IEEE 802.3cg
PLCA Status Reporting
August 15th, 2018

Proposed Text Changes

Figure 148-4—PLCA Control state diagram (1 of 2)

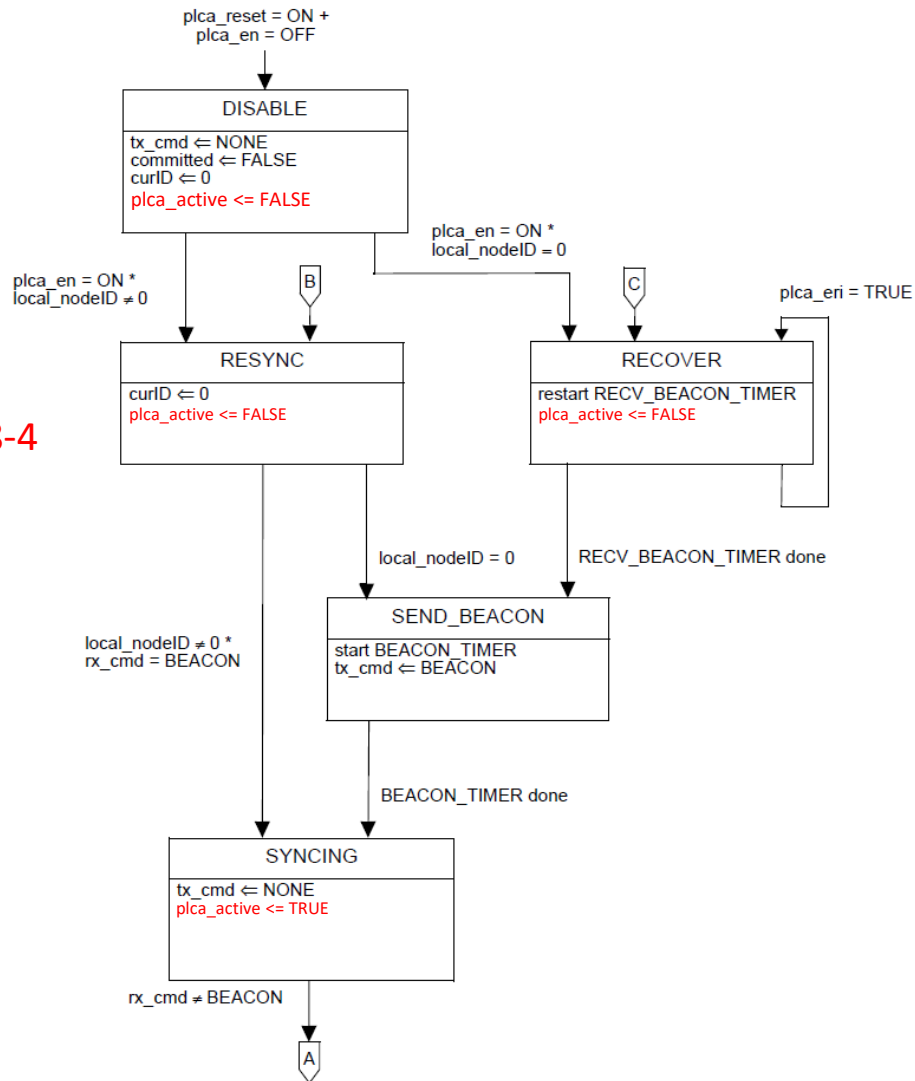
- 148.4.5.2 PLCA Control variables

`plca_active`

notifies the PLCA Status function whether the node is waiting for sending or receiving a BEACON or it already sent or received one.

MODIFY
FIGURE 148-4

Figure 148-TBD PLCA Status state diagram

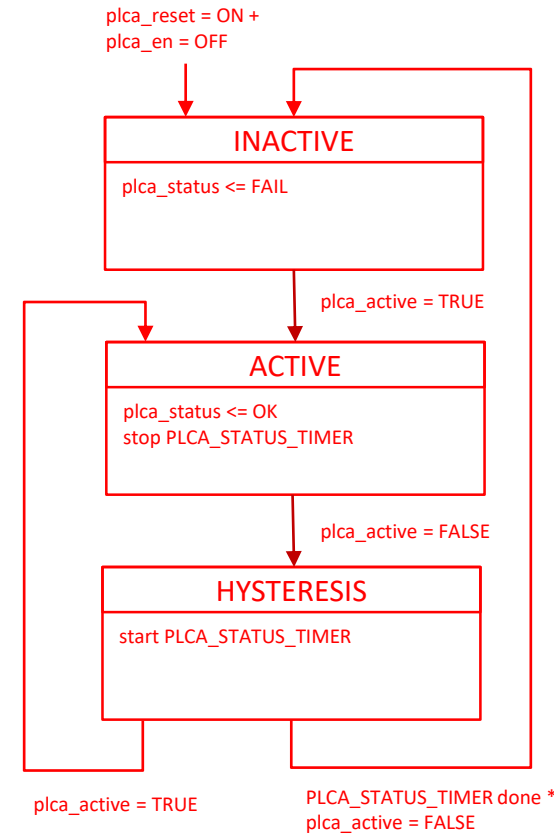
PLCA Status State Diagram is responsible for reporting whether nodes are actively sending / receiving the BEACON.

The PLCA Status function shall conform to the PLCA Status state diagram in Figure 148-TBD and associated state variables, functions, timers and messages.

Upon reset or when PLCA is disabled, PLCA Status function enters “INACTIVE” state and reports `plca_status` as “FAIL”. As soon as the PLCA Control function enters the SYNCING state (i.e. receiving or transmitting the BEACON), `plca_active` variable is set to TRUE and PLCA Status switches to ACTIVE state, reporting `plca_status` as “OK”.

From “ACTIVE” state, whenever `plca_active` is set to FALSE by PLCA Control function, the PLCA Status function enters “HYSTERESIS” state, still reporting `plca_status` as “OK” and arming `PLCA_STATUS_TIMER`.

If `plca_active` is reset to TRUE, then PLCA Status reverts to “ACTIVE” state, effectively filtering the momentarily inactive state. Instead, if `PLCA_STATUS_TIMER` expires while `plca_active` is still FALSE, the PLCA Status function reverts to “INACTIVE” state, reporting `plca_status` as “FAIL”.

ADD
FIGURE 148-TBD
IN CLAUSE 148.4.7
